**To:** Brad Sedgewick  
**From:** Jeff Walton, Associate Planner; 910-341-3260  
**CC:** File; Protrak  
**Date:** 12/5/2012  
**Re:** Fiat of Wilmington Planning Comments

**SITE PLAN**  
**FIAT OF WILMINGTON**  
 6421 MARKET STREET  
 WILMINGTON, NORTH CAROLINA

SHEET  
**C2**  
 JOB NO. 032-011

**SITE PLAN**  
 SCALE 1" = 30'

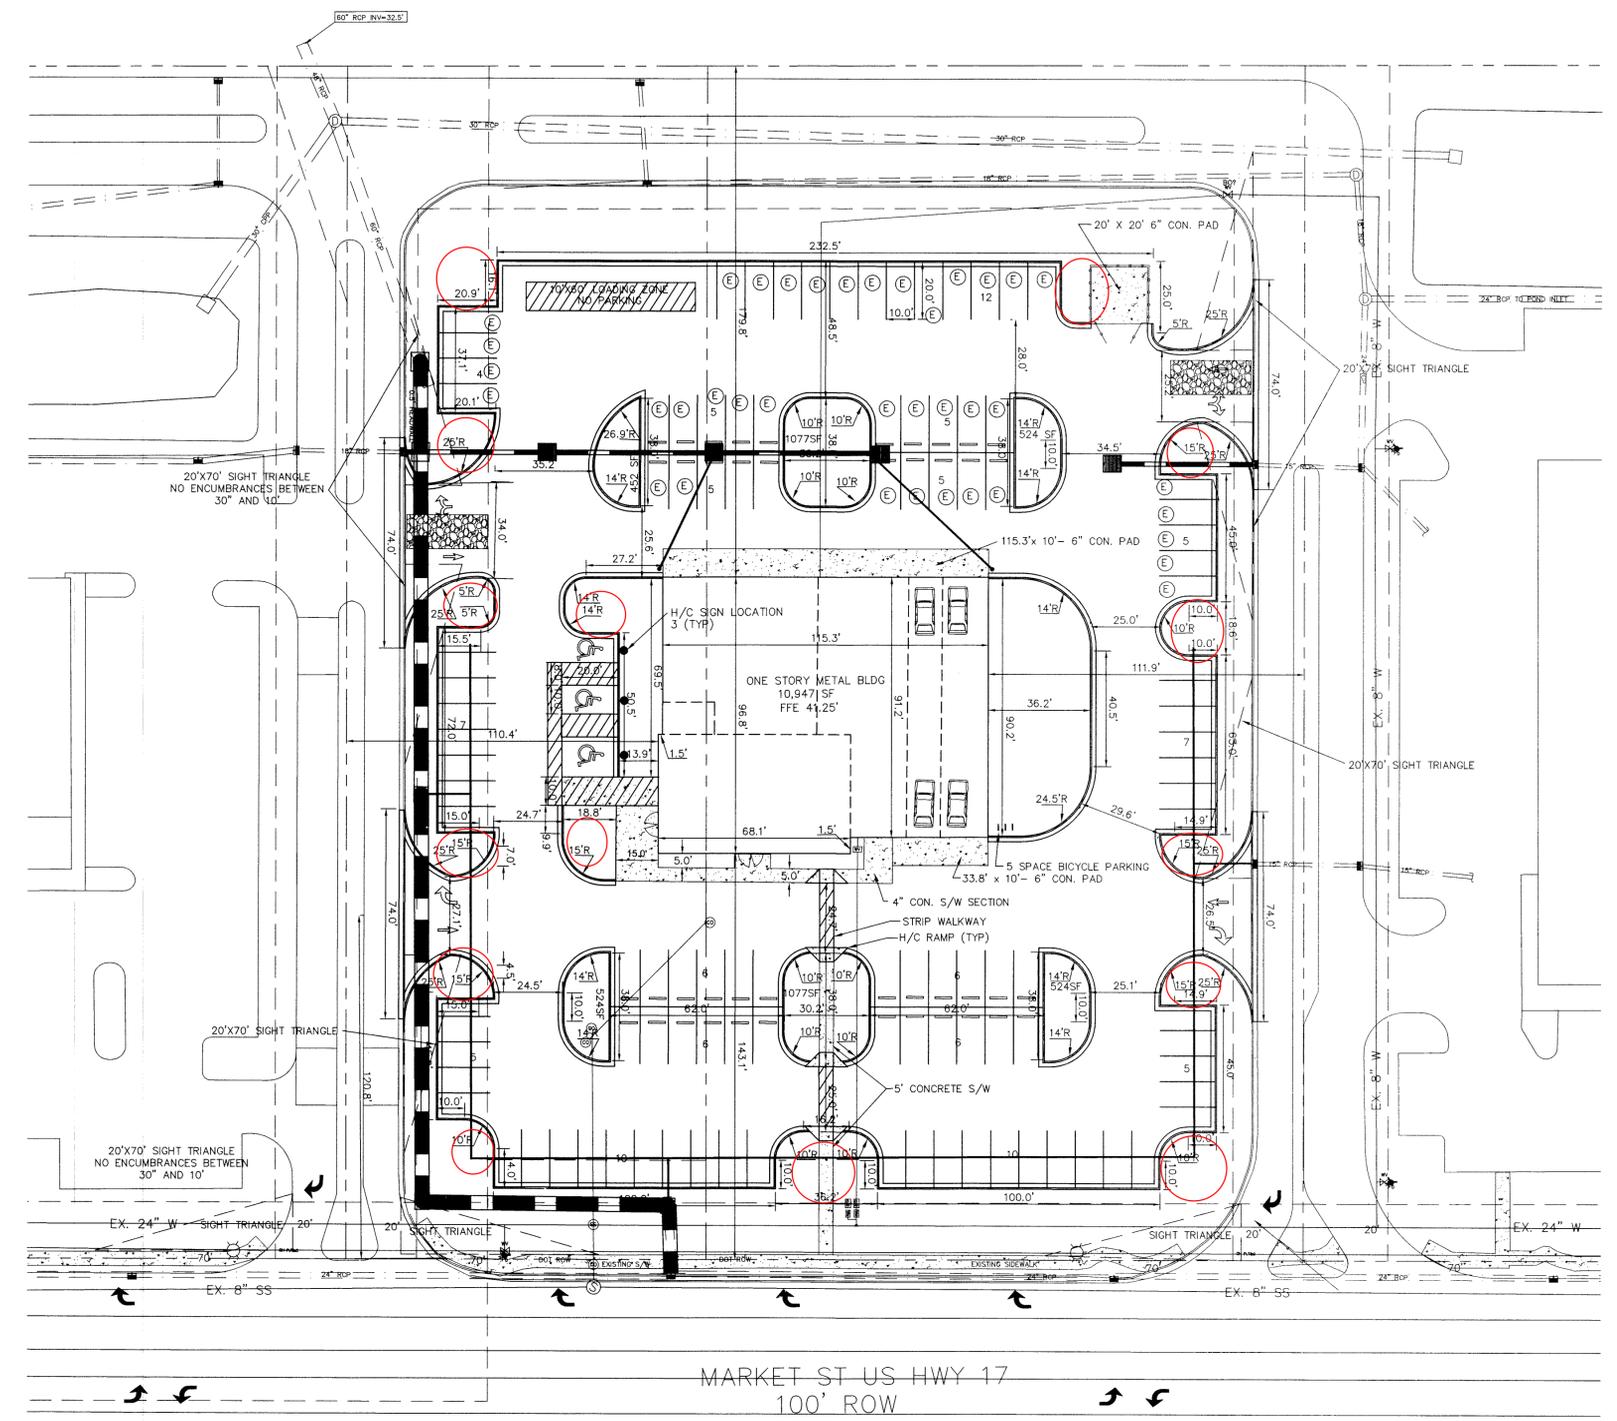
- At the ends of parking rows, show SF of each landscape island on site plan. Single rows require 216 SF and double rows require a min of 432 SF.
  - I have circled islands missing the label.

- When a parking facility is within fifty (50) feet of a right-of-way, if the buffer yard provisions of this ordinance do not call for a planted buffer, a low buffer shall be incorporated into the street yard to provide protection from vehicle headlights within the parking lot. The buffer shall consist of shrubbery, a grade change or planted berm or any combination thereof that serves to shield traffic on the right-of-way from headlights within the parking lot. The buffer shall be a minimum of three (3) feet in height and five (5) feet in width and may be incorporated in a street yard, provided the street yard is fifteen (15) feet or more in width.

- I confirmed with John Fullerton that a display of vehicles is not exempt from this code section.
- **Sec. 18-490. Foundation Plantings** For all portions of buildings which are adjacent to parking facilities or internal drive isles, foundation plantings shall be required and located between the building's facades and the parking or drive isle curb.

- (1) The area of the building face adjacent to the parking area or internal drive isle shall be computed and multiplied by a minimum of twelve (12) percent. The resultant total square footage shall be planted as landscaped areas of sufficient variety, height, and size, with plantings listed in the "Approved Plantings List" of the City of Wilmington Technical Standards and Specifications Manual.

- The area in front of the building facing Market Street is required to have foundation plantings.
  - (2) Exemptions from this requirements may be granted when the following circumstances exist or when any of the following conditions are proposed on the site:
